Product Change Notification

Product Group: SIL/Sun Feb 20, 2022/PCN-SIL-029-2021-REV-1

Vishay Siliconix Announces the Qualification of Single Gauge Lead-Frame for Commercial High Voltage MOSFETs Built in DPAK Package

DPAK Single Gauge vs. Dual Gauge POD Comparison

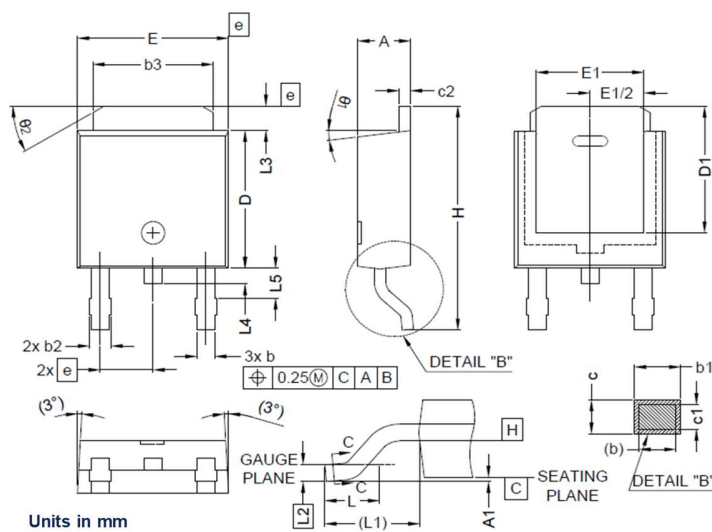
DESCRIPTION OF CHANGE: This notification is made to advise that below mentioned parts packaged in the DPAK built in ASE Weihai factory has been qualified Single Gauge (SG) lead-frame for manufacturing with die size up to 148milX118mils.

This conversion is because Copper Foil supplier, Hitachi Metal, has decided to halt supplies of Copper Foil DPAK Dual Gauge (DG) strategically, which affects down-stream lead-frame stamping house ability to supply DG lead-frame to assembly house ASE Weihai. The qualification of SG lead-frame results no change to any dimension of the POD. The SG lead-frame design has been qualified for Vishay Siliconix DPAK manufacturing at ASE Weihai since 2014.

EXPECTED INFLUENCE ON QUALITY/RELIABILITY/PERFORMANCE: There will be no affect on the quality, reliability, or performance. There will be no changes in minimum and maximum values on the datasheet. The finished good appearance and outline dimension remain no change.
